Office Action Summary

The following correspondence is a non-final Office Action for application # 10/550,394, entitled: PROJECTOR HOLDER, filed on 09/22/2005. Claims 1-11 are pending:

FIG 4

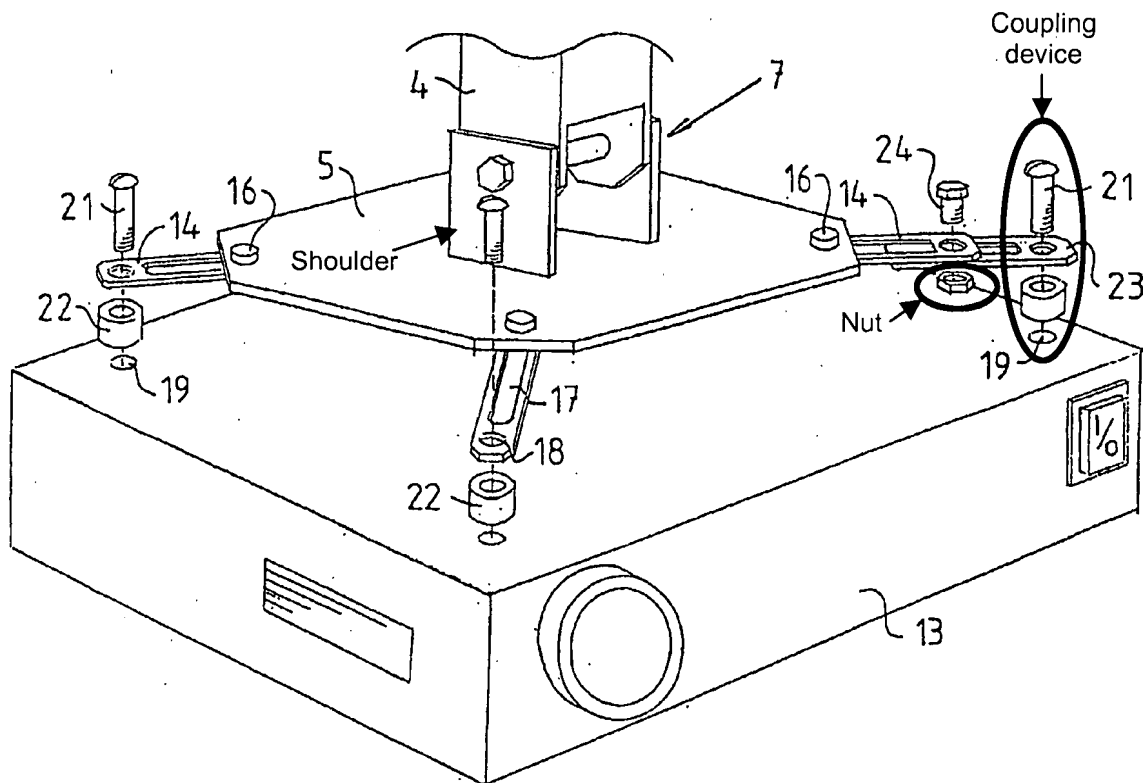
Regarding claim 1, Frisell discloses a projector holder comprising a connecting element 4 which includes a coupling element 7 for connection of the projector holder to a supporting structure, and at least three arms 14,15 which are carried by the connecting element 4 for rotation about mutually parallel axes and for radial displacement relative to the axes, so that a first end 23 of the arms 14,15 can be brought into alignment with threaded openings 19 in a wall of a projector housing 13, where each arm 14,15 carries a coupling device (as shown in Fig. 4 below) for

connecting the first end **23** of a respective arm **14,15** to a nearby threaded opening **19** in the wall of the housing **13**, and where the connecting element **4** is adapted to releasably secure the second end portions (via **16**) of the connected arms **14,15**, characterized in that the coupling device includes a screw **21** which extends through an opening **26** through the first end portion **23** of a respective arm **14,15** with a given degree of clearance, and two nuts (see Fig. 4 below, and discussion on pg. 6, lines 5-14 of specification) which co-act with the thread on the screw **21** and each of which is mounted on a respective side of the arm **14,15**, wherein the thread on the screw **21** is able to co-act with the thread in the opening **19** of the projector housing **13** wall, such as to enable the screw **21** to be screwed to a desired depth in threaded openings **19** in the housing wall **13**, where the nuts can be moved along the screw **21** in a manner to locate the arm **14,15** at a chosen distance from the housing wall **13** and such as to be tightened against the arm **14,15** and therewith secure the screw **21** against rotation.

With regards to claims 4, 7, and 8, Frisell teaches the projector holder, characterized in that the arms **14,15** have generally a flat cross-sectional profile so as to support stably against each other in the connecting element **4**.

Regarding claims 5, and 9-11, Frisell further discloses the projector holder, characterized in that the arms **14,15** are generally straight, so as to extend generally radially to the screw **11** of the connecting element that carries the tightening nut **12** of the element **7**.

With regards to claim 6, Frisell goes on to teach the projector holder, characterized in that the screw **11** of the connecting element **4** includes a shoulder (as shown in Fig. 4 below) that supports against an adjacent arm (via **5**).
